CITY OF SAUSALITO

Addendum No. 2

Issued **June 6, 2016**

Gate 5 Road Sewer Rehabilitation

UNIFORM STANDARDS ALL CITIES AND COUNTY OF MARIN	MONUMENTS	REV.	DATE	BY	MAY 2008 DWG. NO. 300

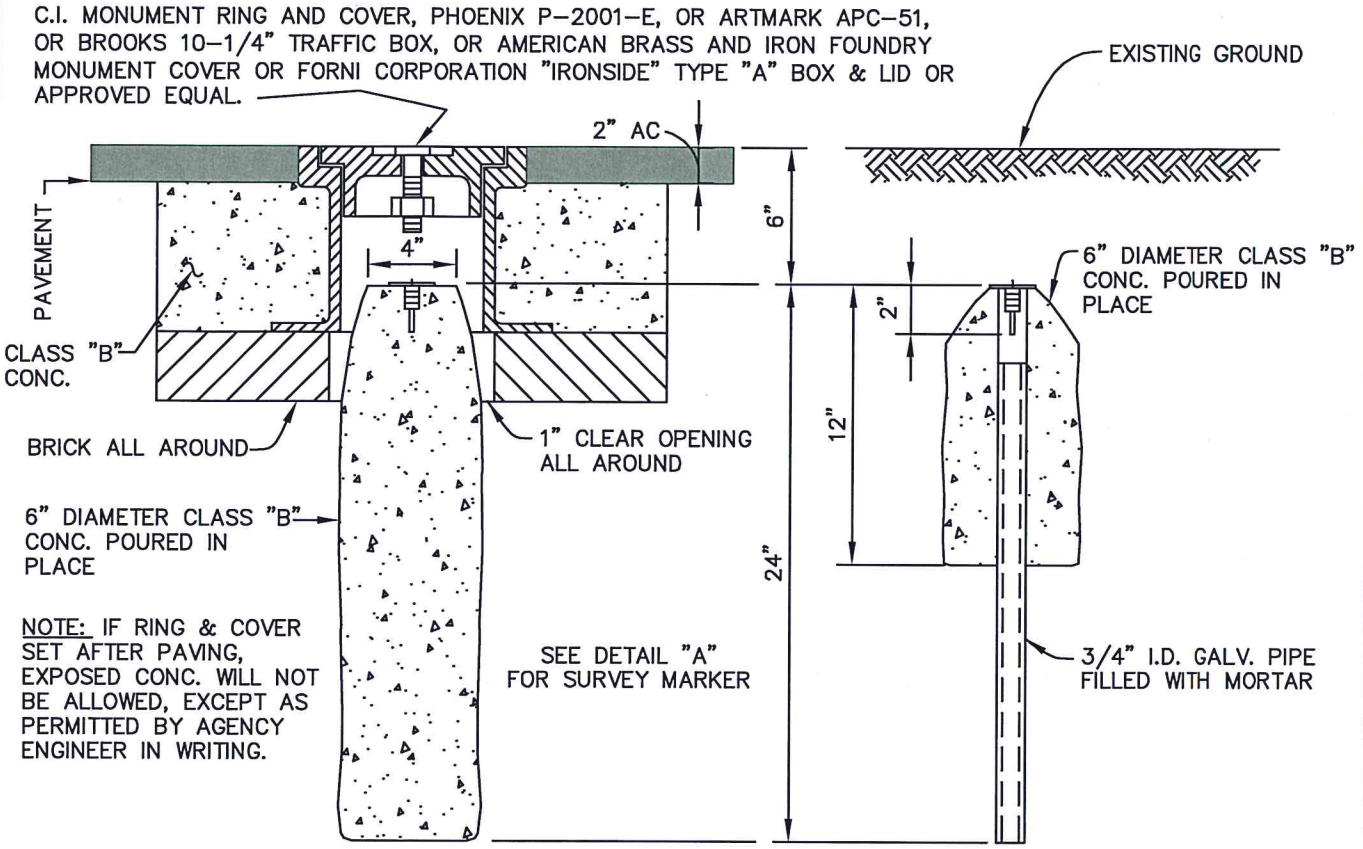
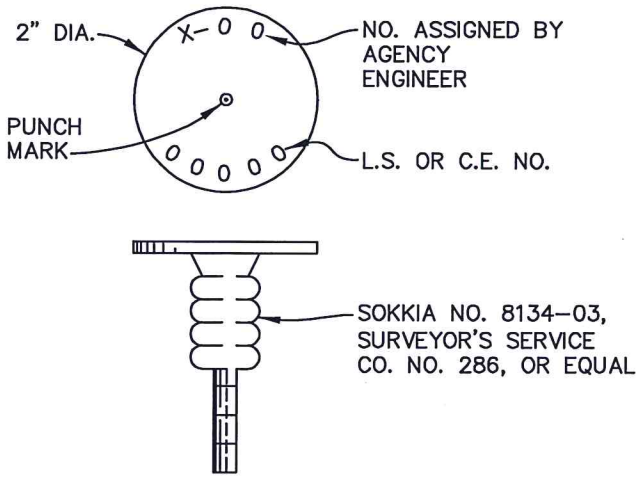
1. Under Legend, insert second symbol for a monument:.o
2. In General Note 1, line 1, insert after "all existing sewer mains" the following text "and 3 private sewer laterals shown on drawing C01"
3. Insert at end of General Note 7 "Monuments shall be replaced according to Uniform Constructions Standards All Cities and County of Marin Drawing No. 300 - Monument. See Appendix G."

1. Add attached Detail 300 - Monuments (1 page).
